RE: Docket 4218 - Electric Infrastructure, Safety, and Reliability Plan FY 2012

**Electric Infrastructure,
Safety, and Reliability Plan
FY 2012 Proposal**

Copy of National Grid's Responses to
Rhode Island Division Data Requests
(Sets 1, 2, and 3)

National Grid Responses
to
Division's First Set of Data Requests

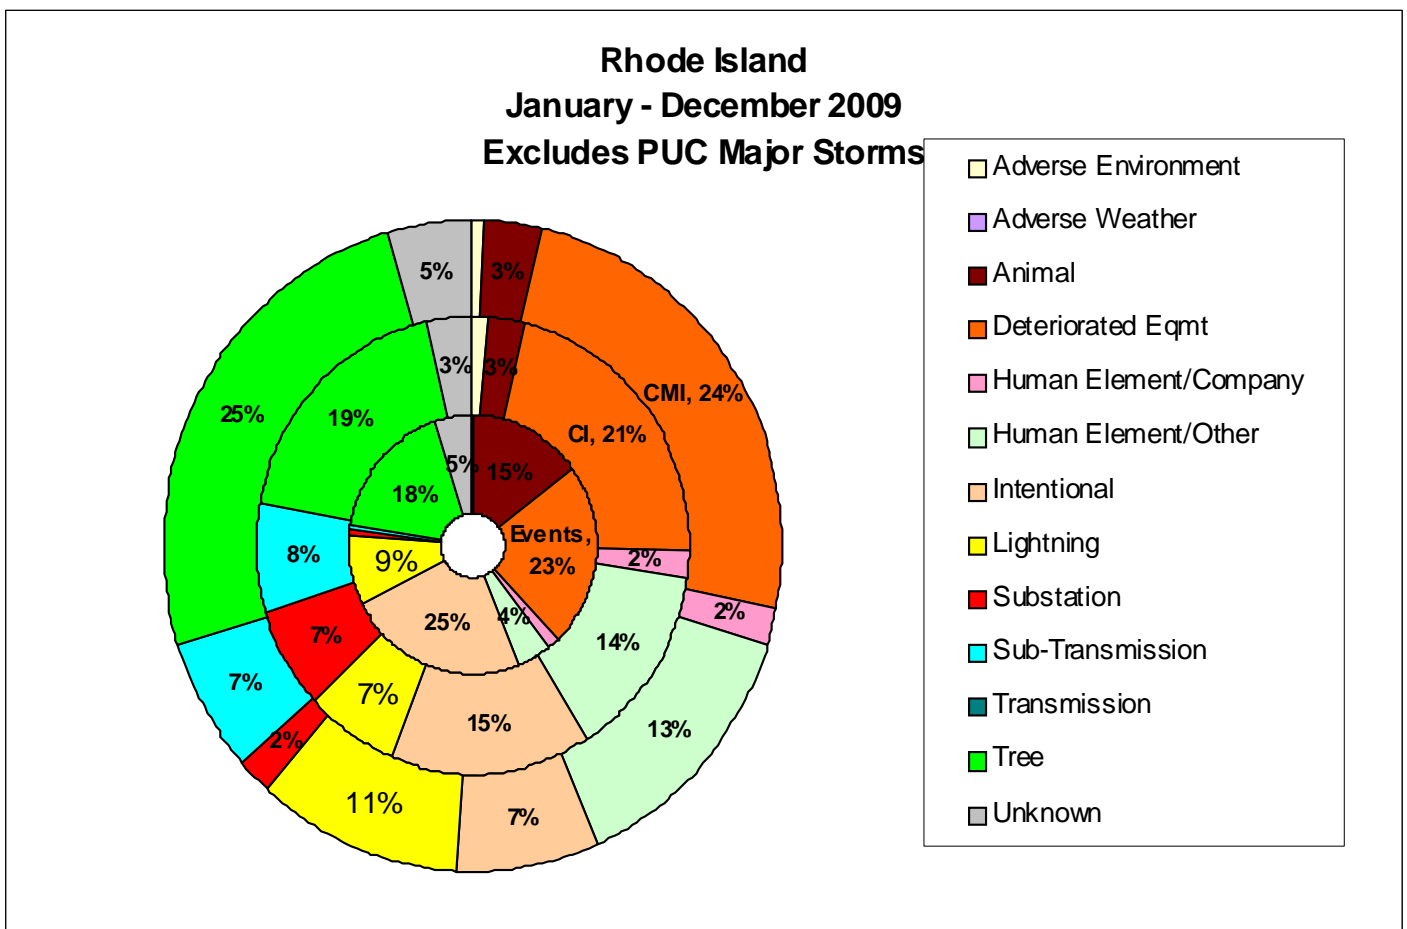
Page 47, Chart 1 of the ISR Plan includes Major Storm Events. Please provide data excluding major storms in the same format.

Chart A

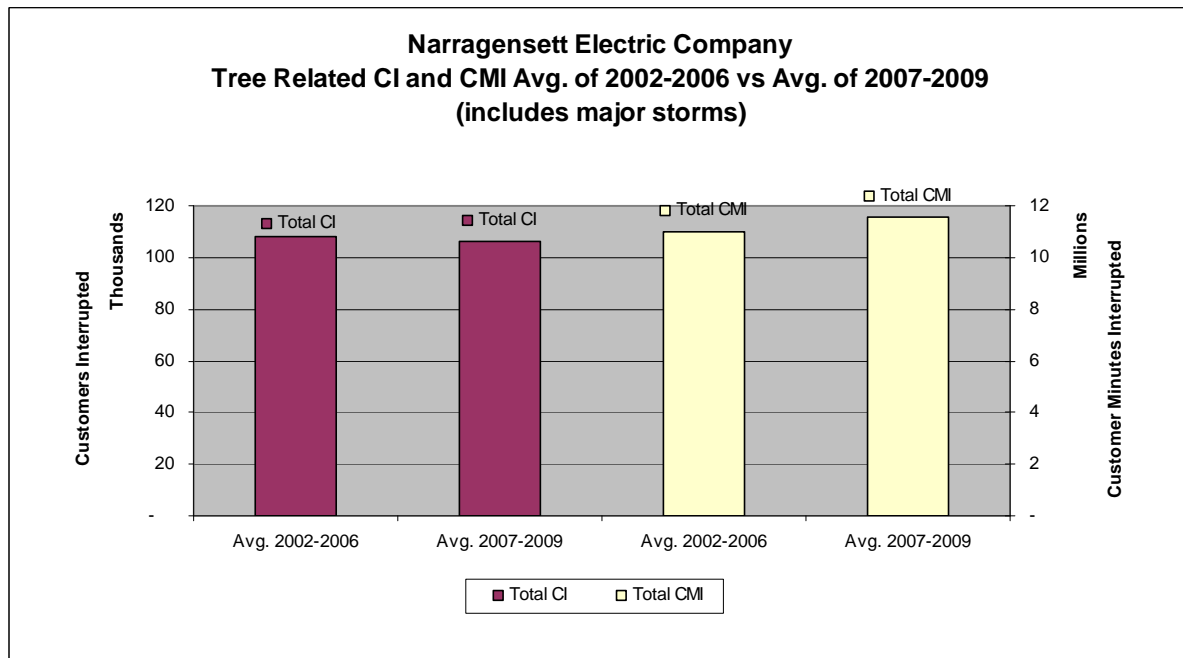
The Chart 3 on page 57 includes major storm events but the Company has since discovered that errors were made in pulling the data used to generate this Chart. The corrected chart including major storms is shown below as Chart A.

Chart A shows that the average number of customers interrupted (“CI”) due to trees is down 2,091 since the Company has improved its vegetation management programs in 2007. But the Company believes that this decline understates the gain from improvements to its vegetation management program as it suspects that severe weather in 2008 boosted the number of tree-related CI. The effectiveness of the Company’s vegetation management program since 2007 is more evident in Chart B which shows a 10% reduction in the average number of tree-related CI per Event since the Company improved its vegetation management programs.

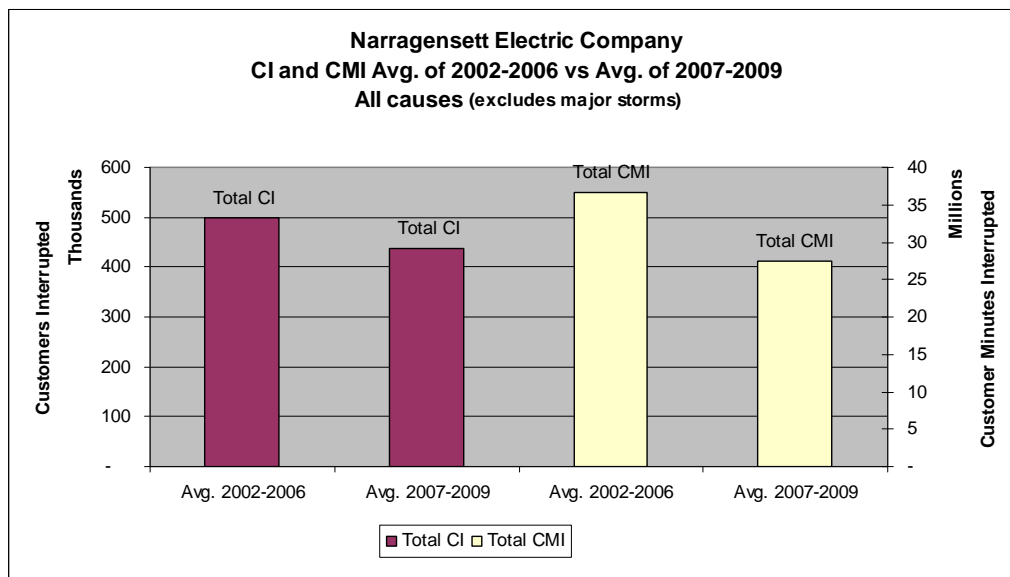
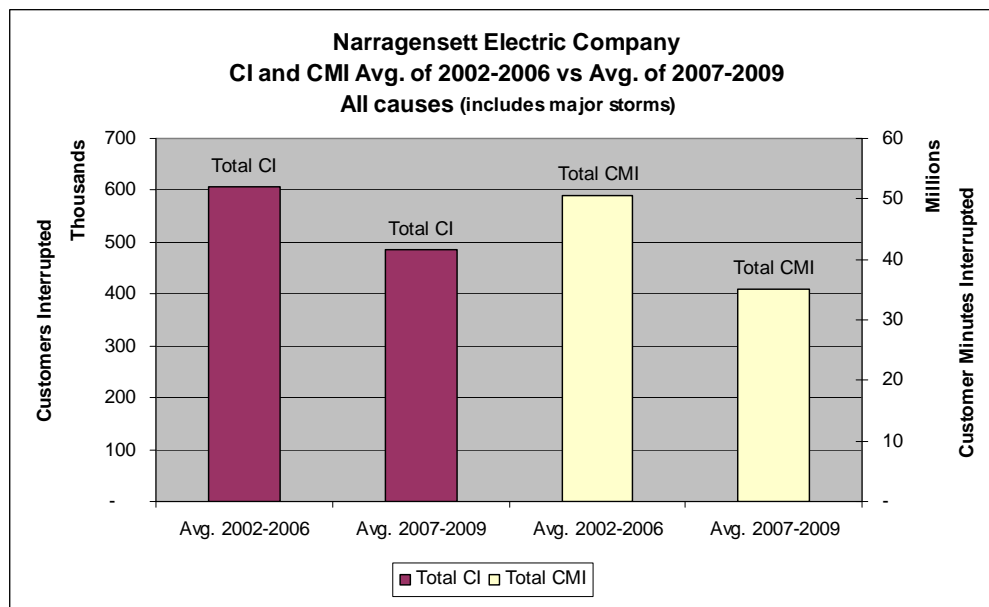
Page 57, Chart 3 of the ISR Plan provides Customer Minutes Interrupted and Customer Interruptions Caused by Trees. Please provide similar format for all interruptions, both with Major Storms and Without Major Storms.
